NUMBER: 13-001-01

GROUP: Frame

Creak-Like Sound Coming From Front End Of Vehicle

2002 (KJ) Liberty

Fig. 1 FRONT SKID PLATE

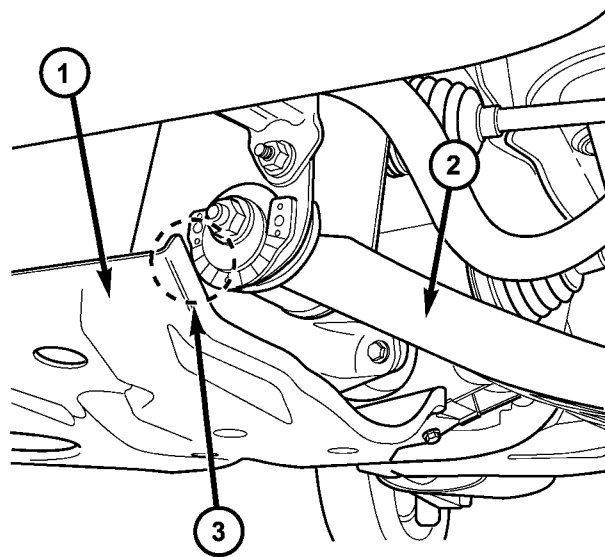
Determine if the left forward corner of the front skid plate has made contact with the front crossmember. Refer to the figure below for illustration of the possible contact area. If evidence of contact is present perform the Repair Procedure.

1. Loosen, but do not remove, the four skid plate attaching bolts.
2. Slide the front skid plate as far to the right (passenger side) of the vehicle as is possible. While holding the skid plate in place, tighten the four attaching bolts.
3. With the front skid plate repositioned to the right side, measure the clearance between the left forward corner of the front skid plate and the front crossmember (Fig. 1).

4. If a clearance of 3.1 mm (1/8 in.) or more is now present between the front skid plate and the front crossmember, tighten the front skid plate attaching bolts to 61 Nm (45 ft. lbs.). A new front skid plate is not required.
5. If the clearance between the front skid plate and front crossmember is less than 3.1 mm (1/8 in.), install a new front skid plate.
6. Position the new front skid plate to right side and tighten the front skid plate attaching bolts to 61 Nm (45 ft. lbs.).

NOTE: THE TECHNICIAN SHOULD BE AWARE THAT WHEN A FRONT SKID PLATE IS INSTALLED FOLLOWING ANY SERVICE ACTIVITY, THE SKID PLATE SHOULD BE POSITIONED AS FAR TO THE RIGHT SIDE OF THE VEHICLE AS IS POSSIBLE. THIS SHOULD HELP PREVENT POSSIBLE CONTACT BETWEEN THE FRONT SKID PLATE AND THE FRONT CROSSMEMBER.
